REPORT SUMMARY MINOR VARIANCE APPLICATION FILE NUMBER A011/25

Report Date: May 30, 2025

CITY WARD #:	4
APPLICANT:	Adam Ryan Saul & Madison Jill Saul
AGENT:	Contempo Studio
PROPERTY:	107 Sir Modesto Court, Maple
ZONING DESIGNATION:	See below.
VAUGHAN OFFICIAL PLAN (2010) DESIGNATION:	Vaughan Official Plan 2010 ('VOP 2010'): "Low Rise Residential"
RELATED DEVELOPMENT APPLICATIONS:	N/A
PURPOSE OF APPLICATION:	Relief from the Zoning By-law is being requested to permit the construction of a proposed two-storey dwelling and cabana.

1 LANDSCAPE DIAGRAM
1" = 10'-0"

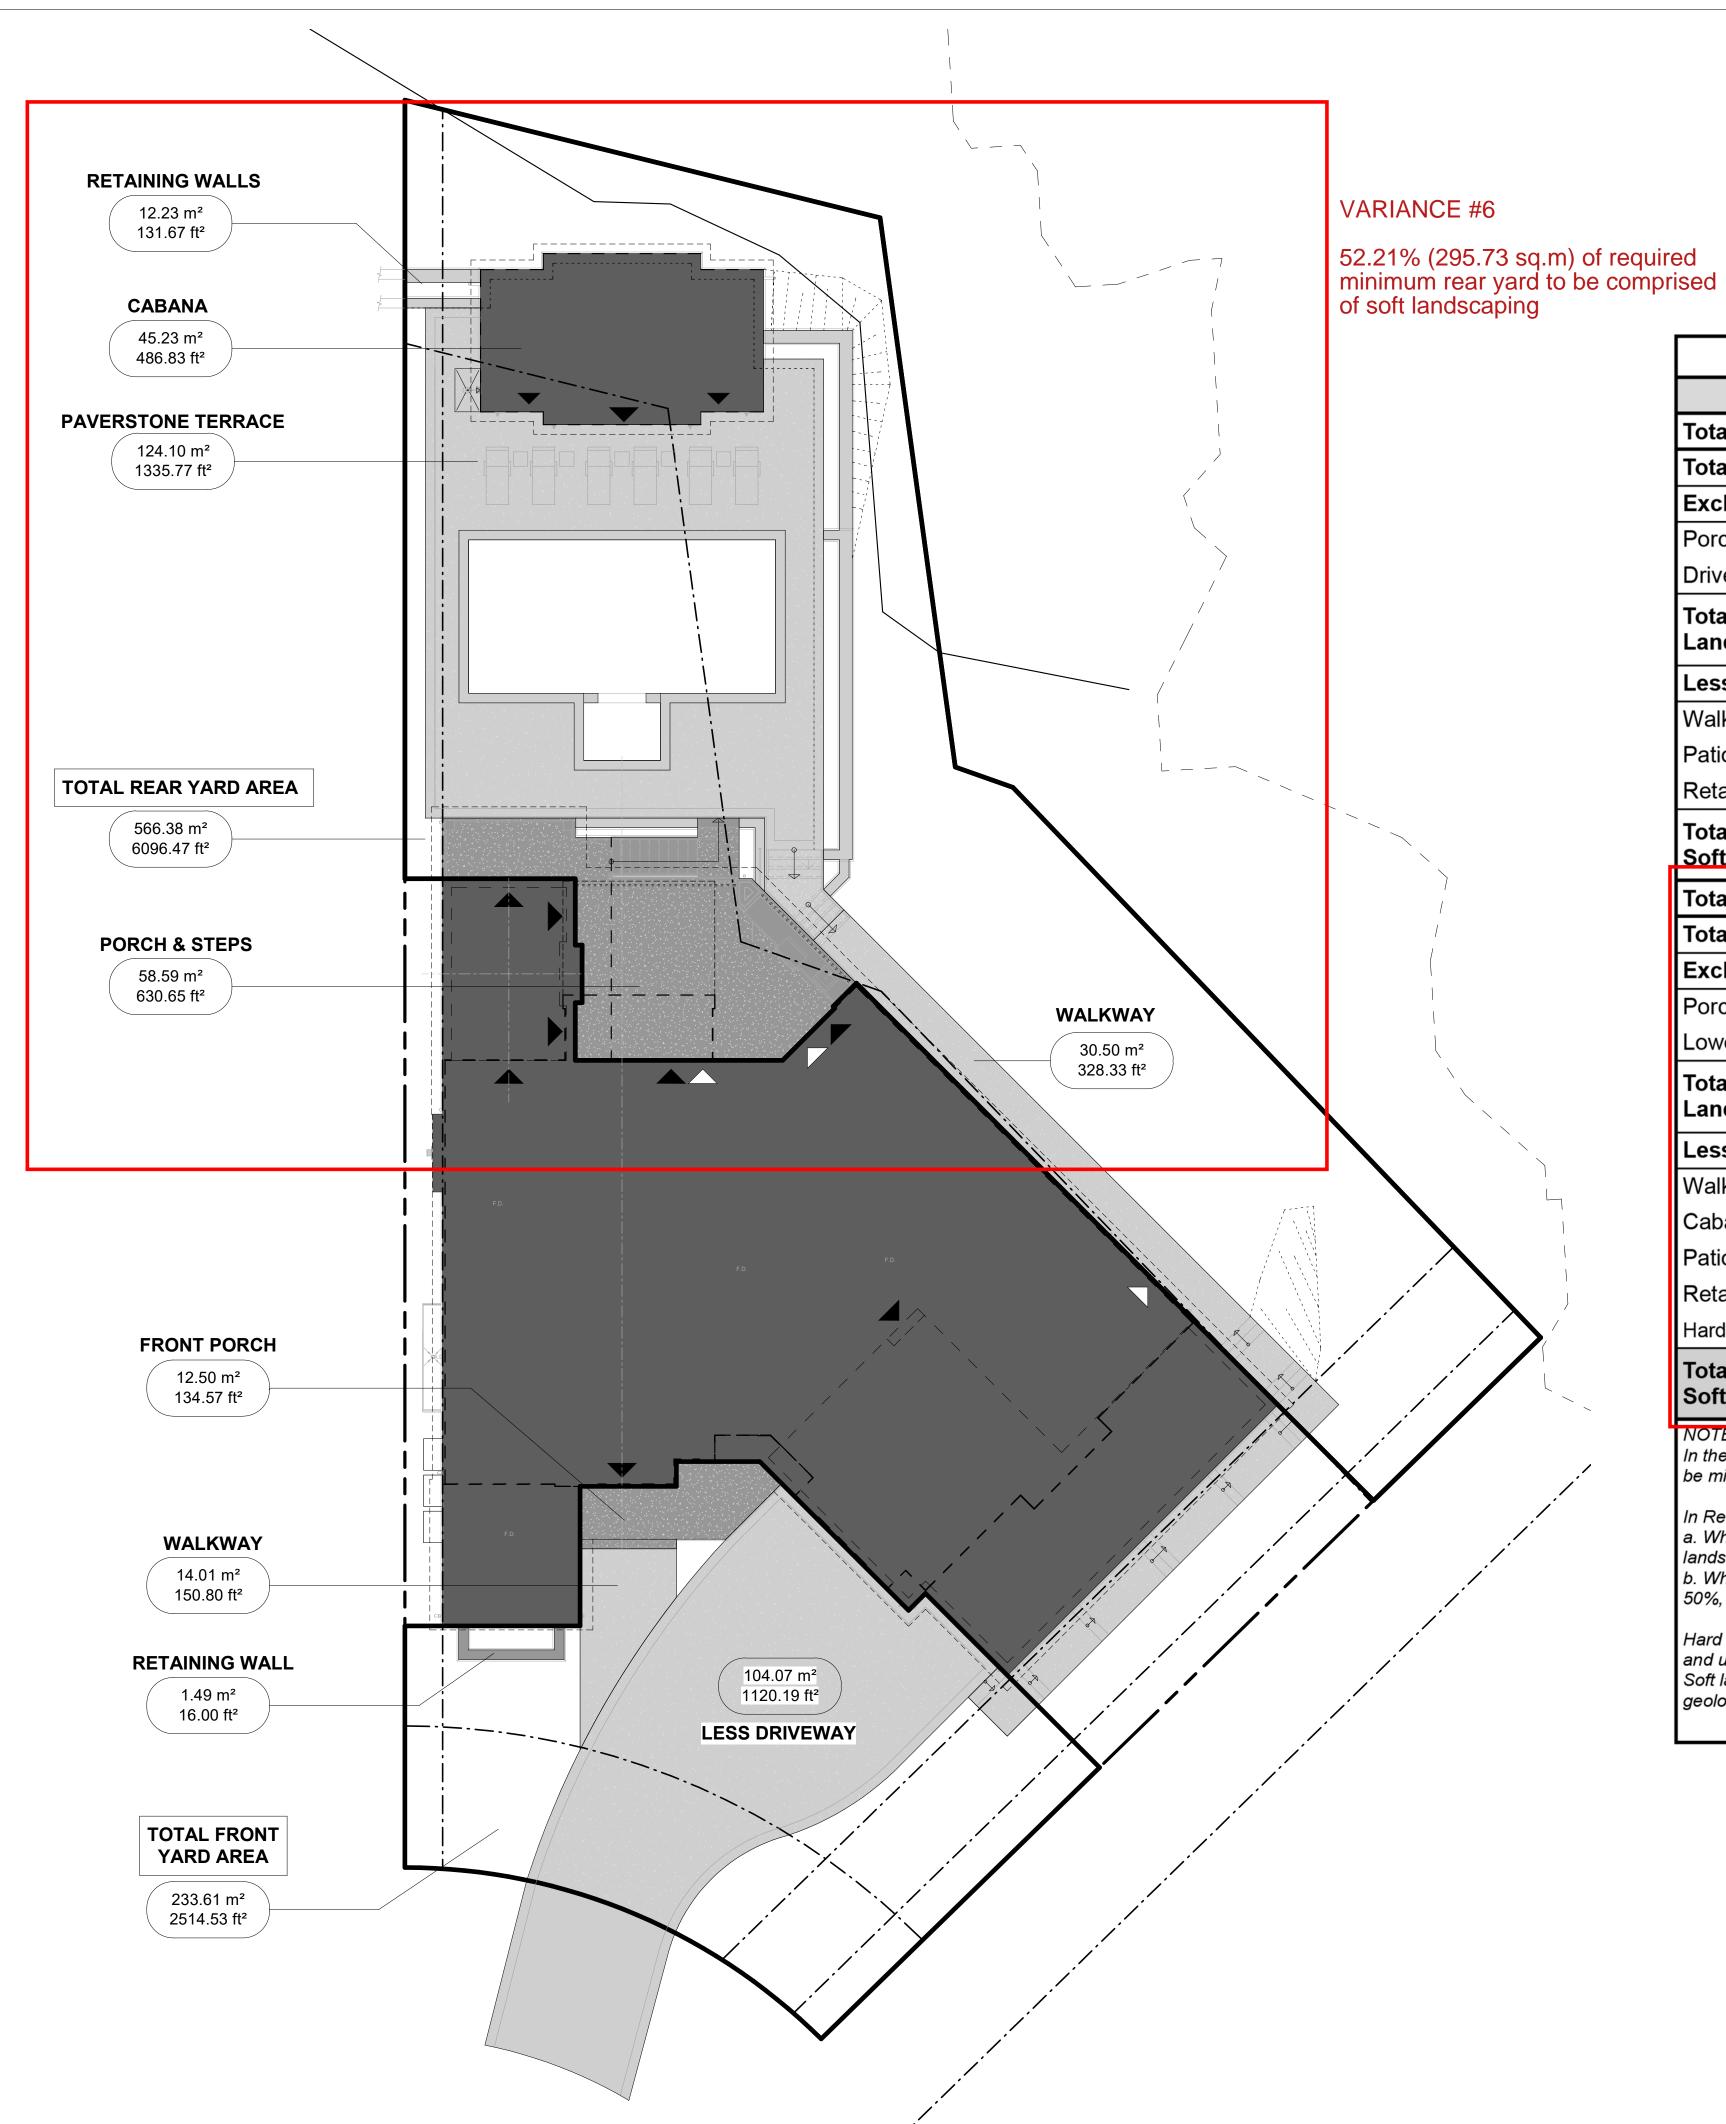
The Development and Parks Planning Department has no objections to Variance 6 to reduce the minimum soft landscaping in the portion of the rear yard in excess of 135 m² from 60% to 52.21%. The reduction represents approximately 44 m² of soft landscaping, which is minor given the size of the rear yard. Development Engineering staff have reviewed the variance and are satisfied that the reduced soft landscaping remains sufficient for stormwater management.

CABANA FRONT ELEVATION

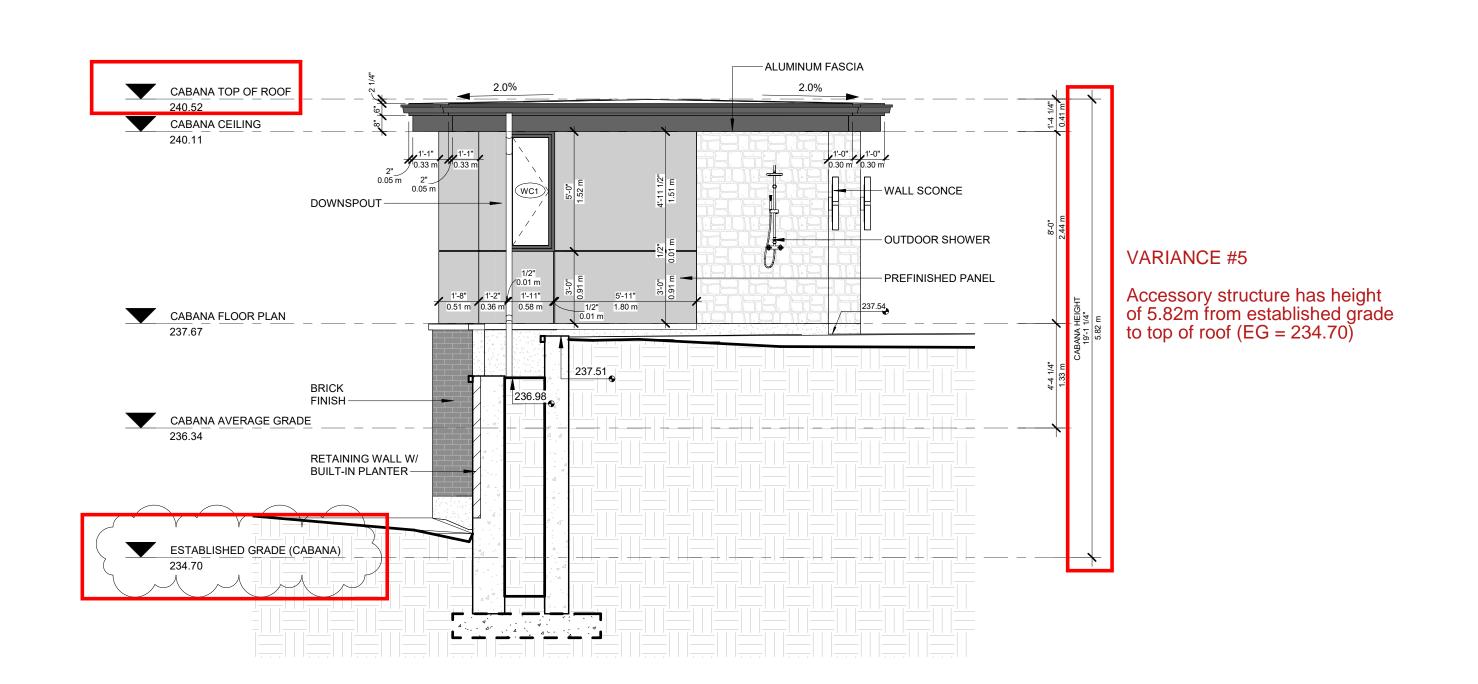
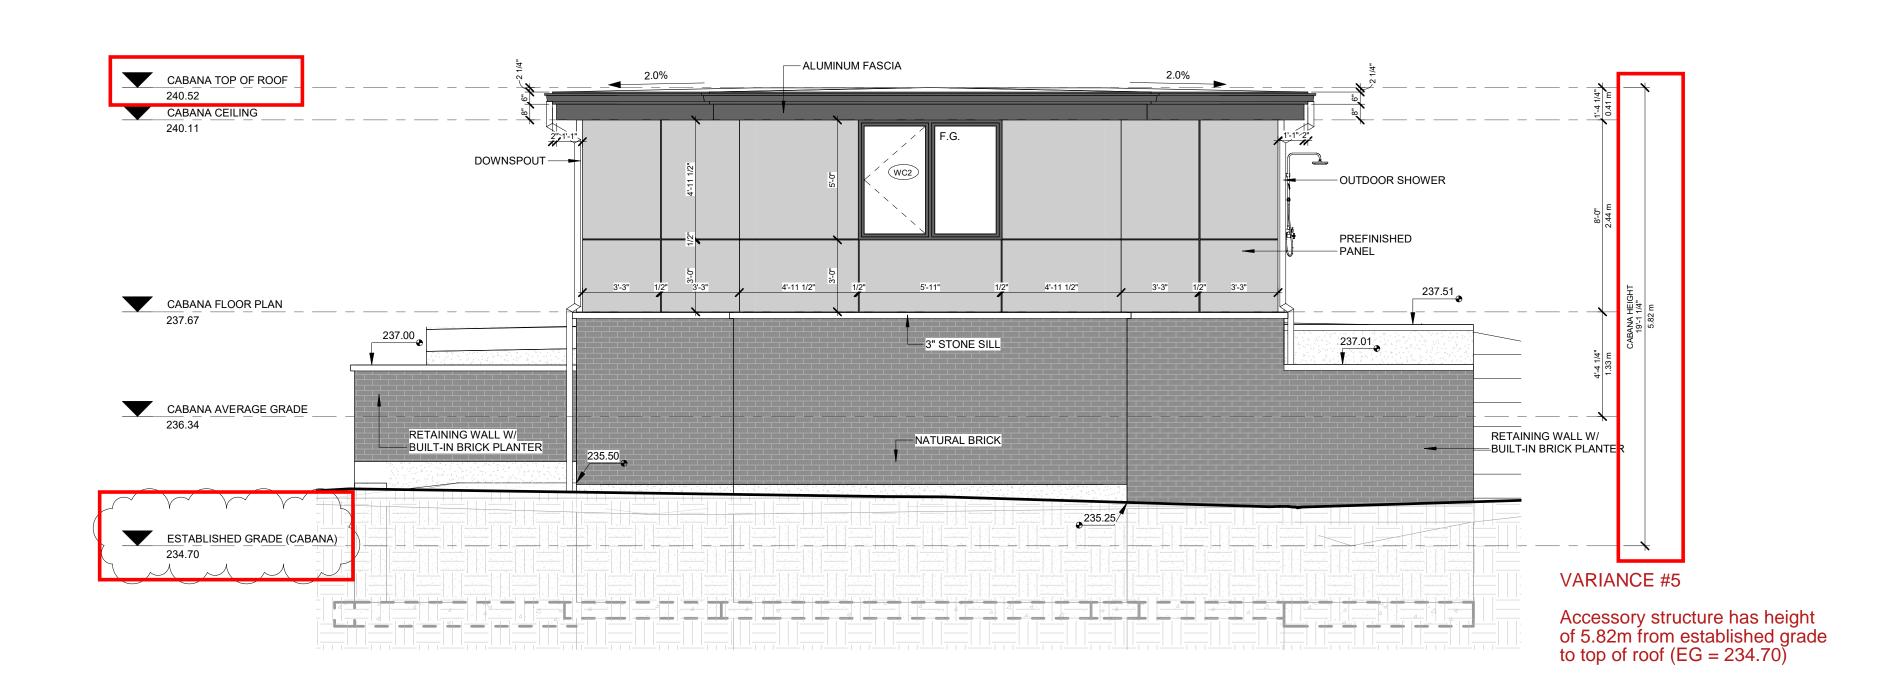
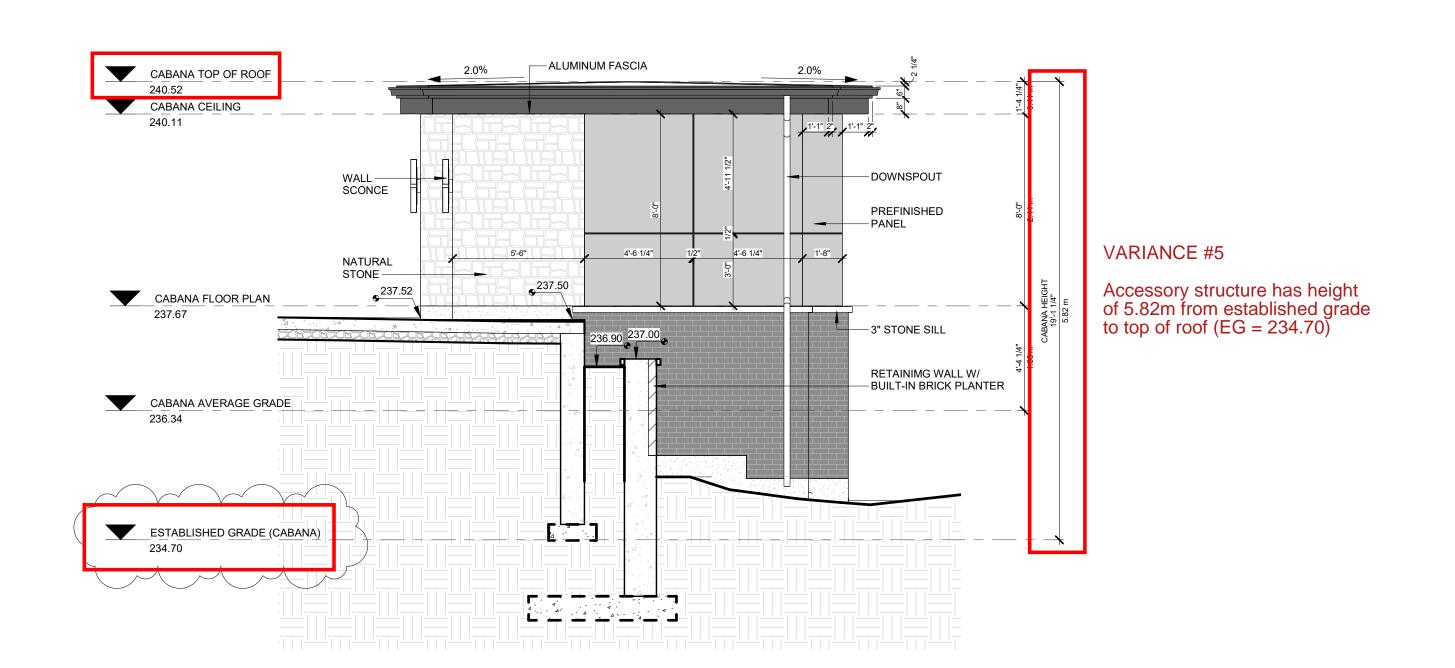
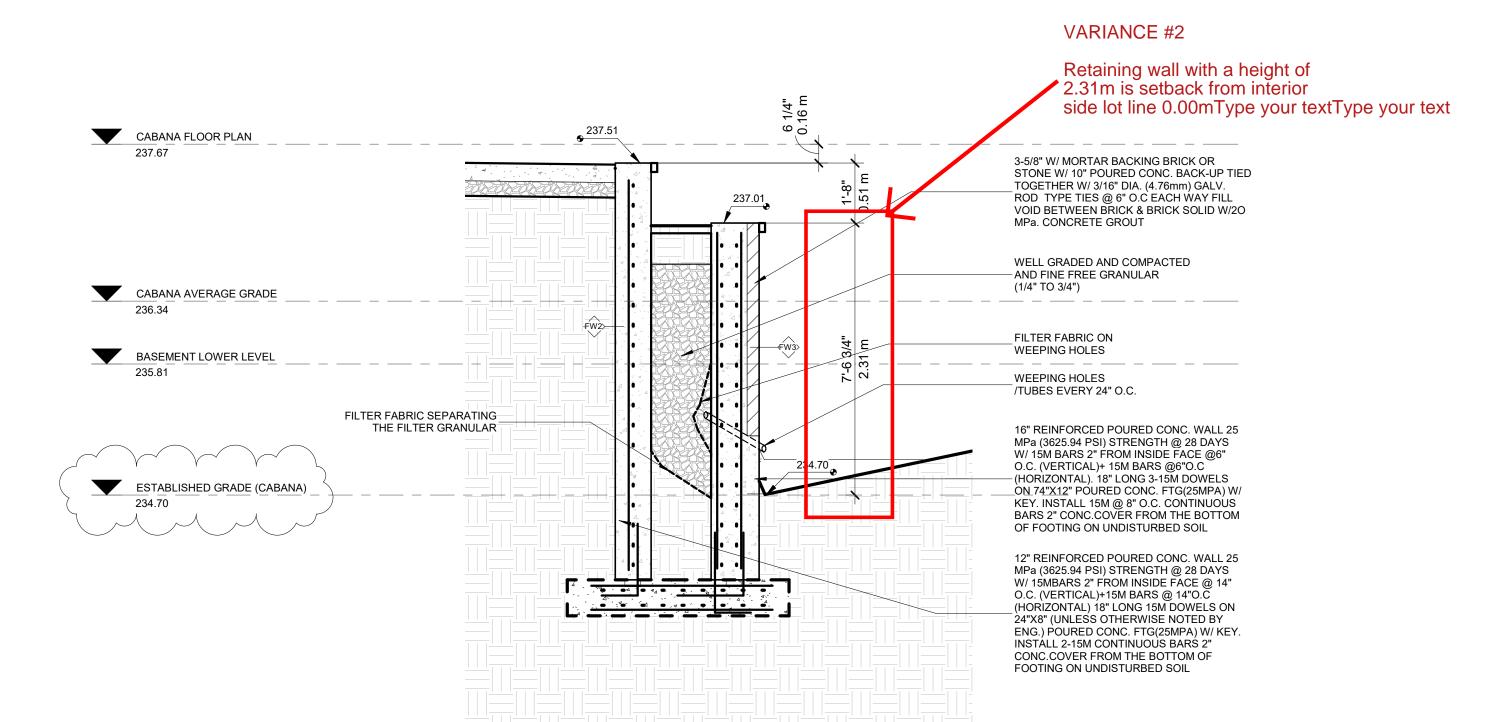
The Development and Parks Planning Department has no objections to Variance 5 to permit a height increase for the proposed cabana from 3 m to 5.82 m. The proposed height is measured from established grade, and the height is most perceived from the rear. The cabana maintains a compliant setback from all lot lines, and is not anticipated to incur massing impacts on neighbouring properties or the public trail to the south.

2 RETAINING WALL SECTION 2
3/8" = 1'-0"

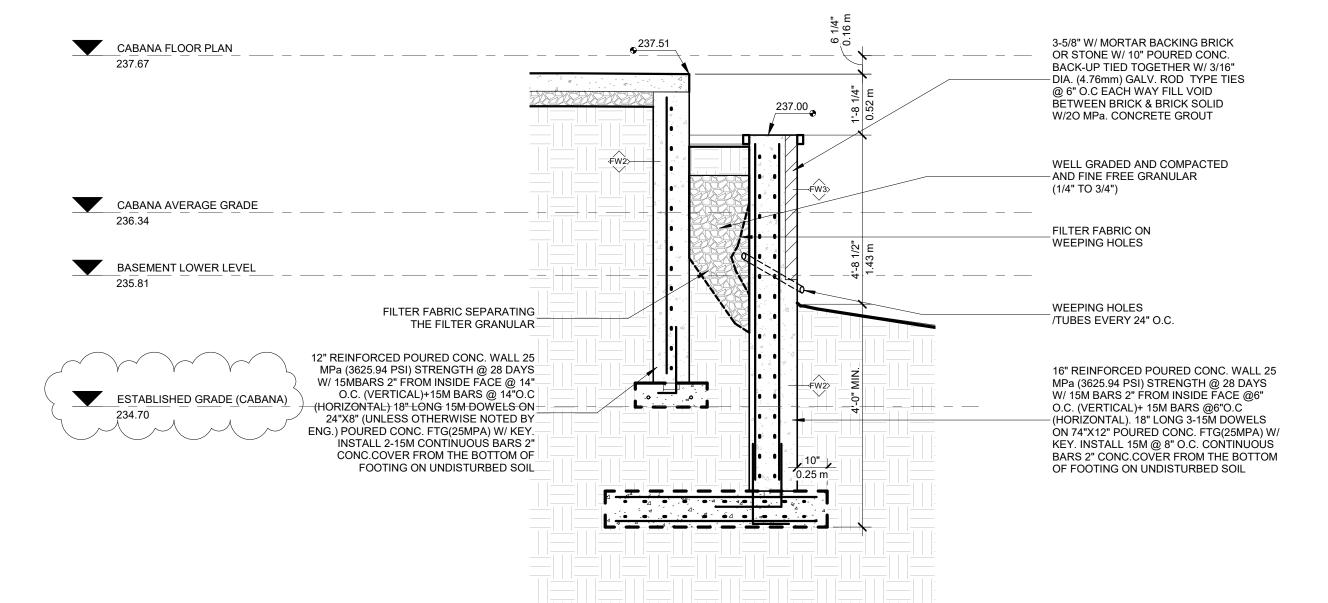
The Development and Parks Planning Department has no objections to Variance 2 to permit a retaining wall to be located 0.0 m from the east interior side lot line. The proposed retaining wall is oriented perpendicular to the eastern interior side lot line and connects to a segment of the retaining wall proposed on 108 Sir Modesto Court, east of the subject property. Consent applications B006/25 and B007/25 have been submitted to facilitate mutual access easements and have been reviewed to the satisfaction of Development Engineering staff.
